ANSWERS TO AEC QUESTIONS

DRESDEN ~~NUCLEAR~~ POWER STATION

AMENDMENT NUMBER 10 FOR UNIT 2

AMENDMENT NUMBER 11 FOR UNIT 3

Fig I.A.1 Loss of Coolant Accident Analytical Procedures

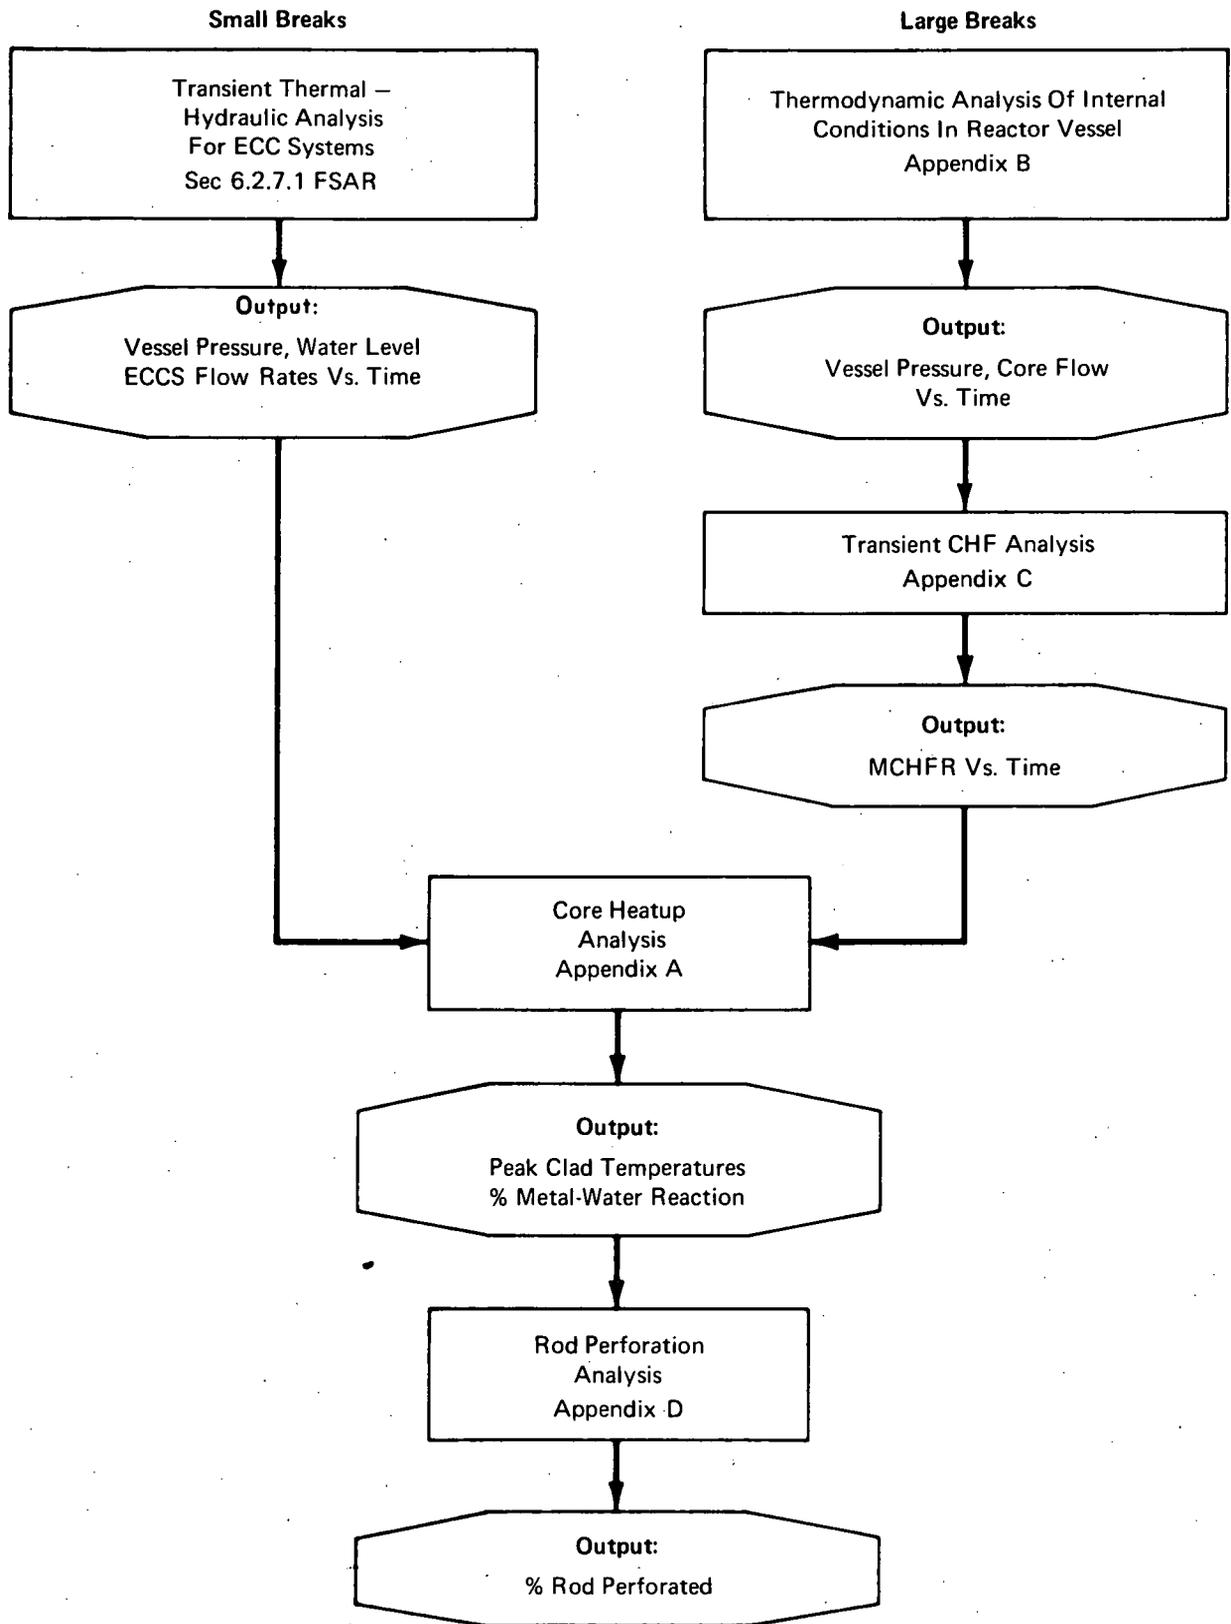
I. A. 1 Provide detailed descriptions of the analytical methods and models, assumptions, and input and output parameters of the new codes used in the Dresden 2/3 LOCA analysis (LAMB, SCAT, and CHASTE). Describe the calculational sequence using these and the other GE codes (RIP and WAZOO-2), and give the break ranges for which the various codes apply.

There are two basic procedures used in the analysis of loss-of-coolant accidents. The particular procedure used is determined by the size of the break being considered, i. e., "small" breaks or "large" breaks. Small breaks are those for which the blowdown transient is very mild and the associated core heat transfer during the entire flow coastdown is essentially identical to a pump trip transient. All key parameters change relatively slowly with time. The blowdown transient begins to have significant effects for breaks in excess of about 0.5 square feet and are thus classified as "large" breaks. Thus, the transient core flow and heat transfer calculations are performed by a different model which includes the blowdown feedback effects on flow. A general outline of the procedures used, the models involved and the results are outlined in Figure I. A. 1.

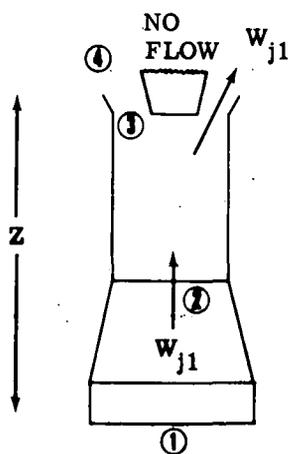
I. A. 2 What are the bases for the conclusions that during blowdown: (a) all of the coastdown flow from the unaffected recirculation loop goes through the core, and (b) there is a 50%-50% flow split between the core and the jet pumps during the period of flashing in the lower plenum.

The above sketch represents the model used in the analysis of transient jet pump performance. Momentum exchange between the drive and suction flows is assumed to occur in a mixing region in the jet pump throat. The suction and drive flows enter

Fig I.A.7 Vessel Pressure And Level Traces - Bodega 30

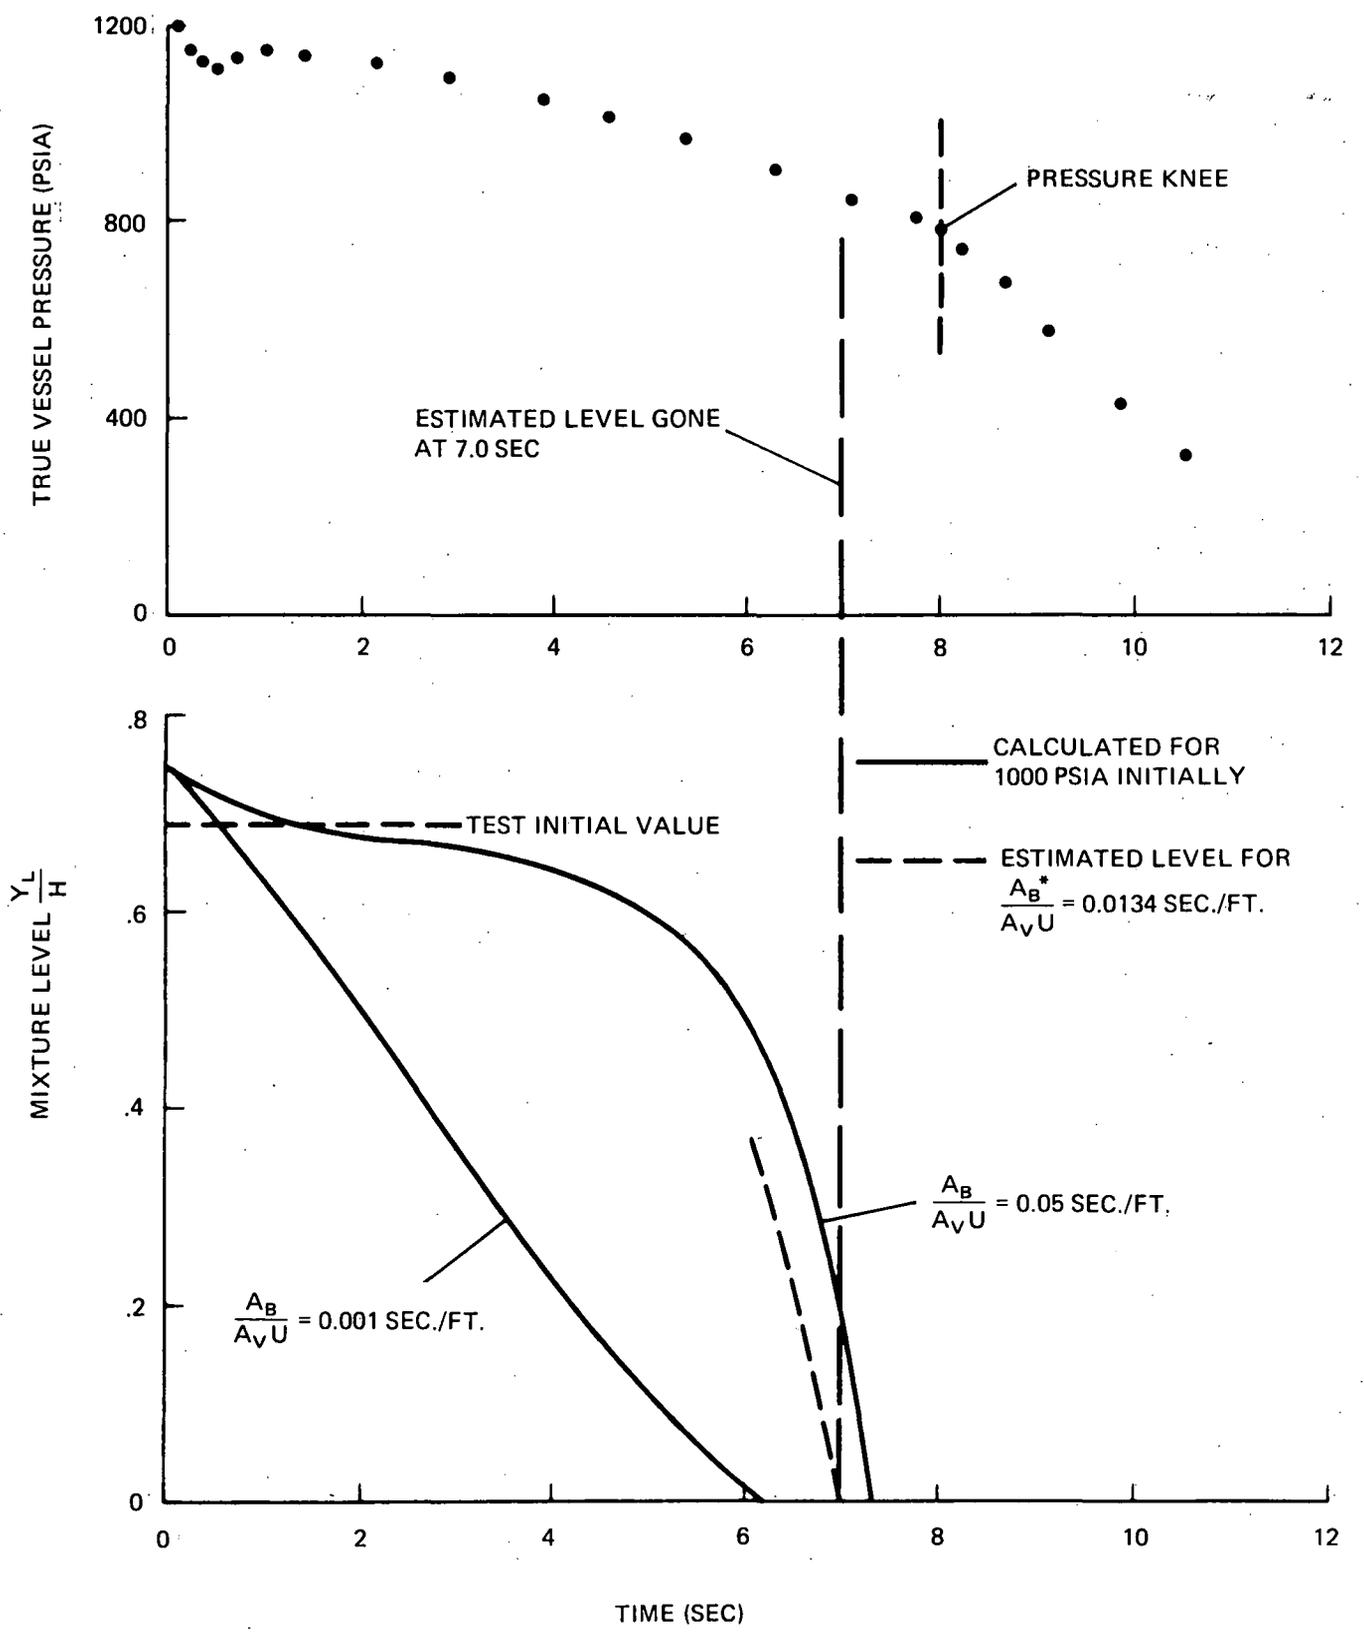
I. A. 6. We understand that the new "level swell" model has been used successfully to predict some data from the Humboldt Bay and Bodega Bay blowdown tests. Please indicate the results of the comparisons between analysis and experiment in sufficient detail to support use of the level swell model.

Rather than calculate level curves for Bodega 30 and Humboldt 17, it was decided to make an approximate comparison with already available calculations from initial vessel pressures of 1000 psia. The tests begin at 1250 psia. Figures I. A. 7 and I. A. 8 show true vessel pressure traces with attention called to the "knee". The lower half of each graph gives mixture level calculations based on 1000 psia, and 75 percent initial water level. A dotted curve also is shown, based on the appropriate $\frac{A_B^*}{A_v u}$. When mixture level reaches zero, the pressure "knee" should occur.

Even though the calculation is based on 1000 psia and the tests were run from 1250 psia, mixture level disappearance was predicted within 12.5 per cent using the model described and this is a direct index of its accuracy.

FIGURE I.B.1 DRESDEN 2, 3 PRESSURE PEAKS VS. CAPACITY TURBINE TRIP WITHOUT BYPASS TRANSIENT

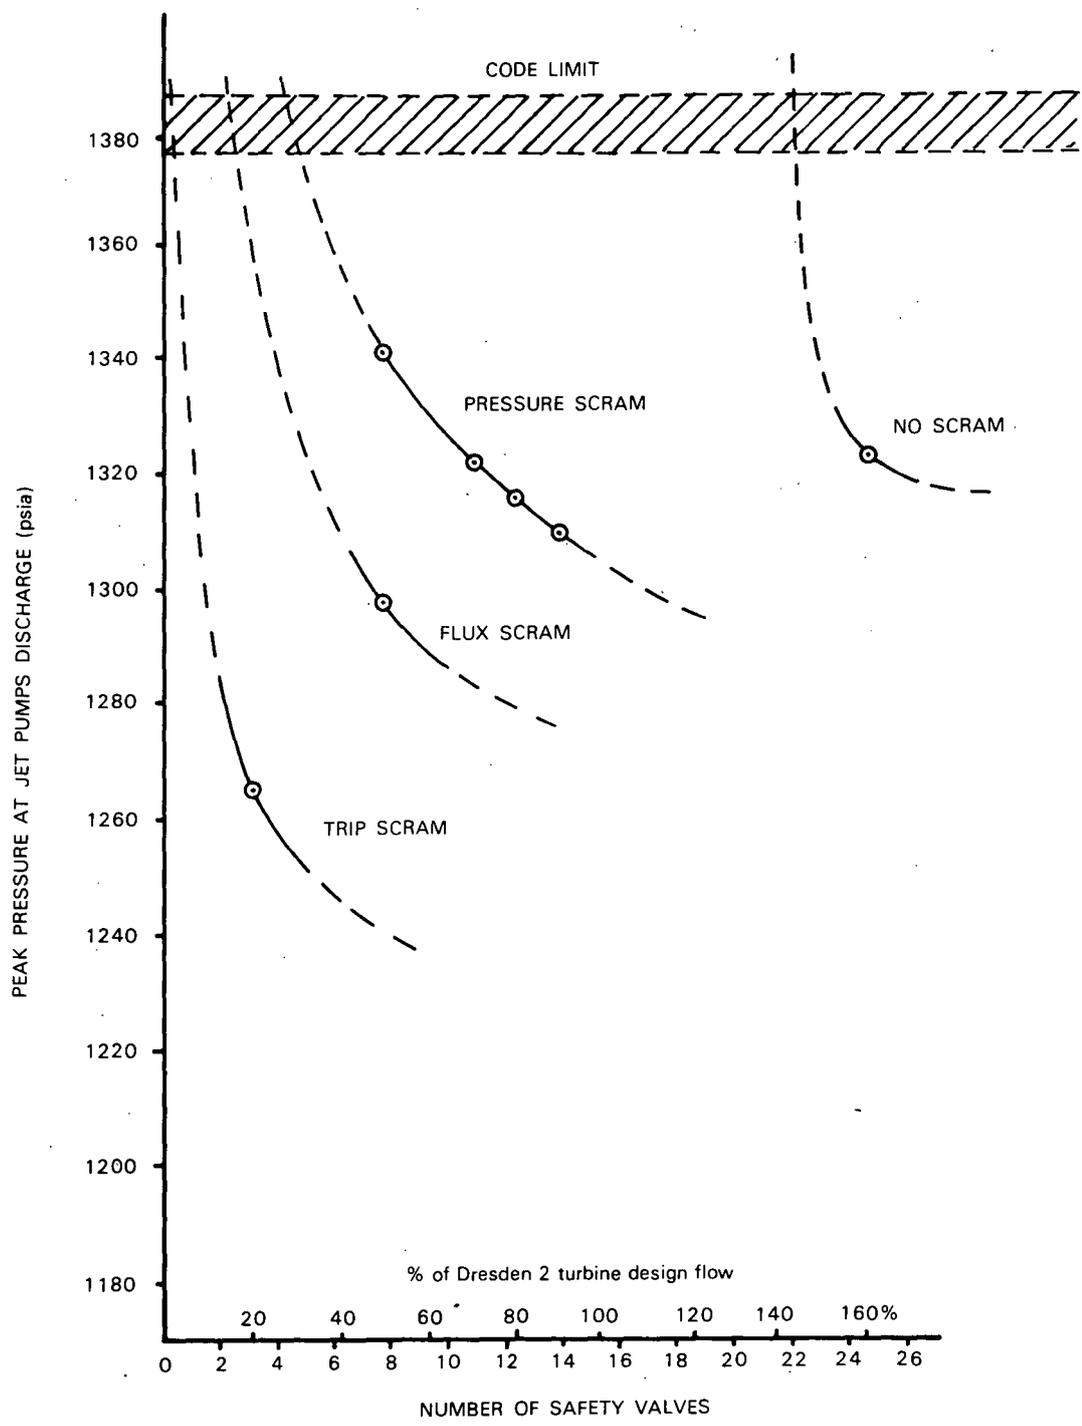
I. B In Amendment No. 7 for Unit 2 and Amendment No. 8 for Unit 3, the number of safety valves was reduced from twenty to eight, with individual valve capacity remaining constant. Please provide sufficient summary technical information required by code in accordance with ASME Section III, N910.2 and a discussion of the margin between the peak allowable pressure and the peak vessel pressure for the transient postulated in Section 4.4.2 but assuming only a high pressure scram. For both the pressure scram and the flux scram transients, show that the assumptions used in the calculations are conservative with respect to the proposed technical specifications for safety system settings (Sections 2.2 and 2.3), control rod insertion times (Section 3.3.A.3), and the number of rods valved out of service (Section 3.3.A.5).

Figure I. B. 1 shows the expected pressure peaks for the Dresden 2, 3 plants that would result as a function of the number of safety valves for the turbine trip without bypass transient. The curves of peak pressure versus capacity are plotted for the cases of no scram, pressure scram, flux scram and trip scram.

The curve showing the pressure scram only transient has not been shown because the Code requires that only the flux scram requirement need be met. It can be seen from Figure I. B. 1, however, that the Code safety limit will not be exceeded even considering the pressure scram only.
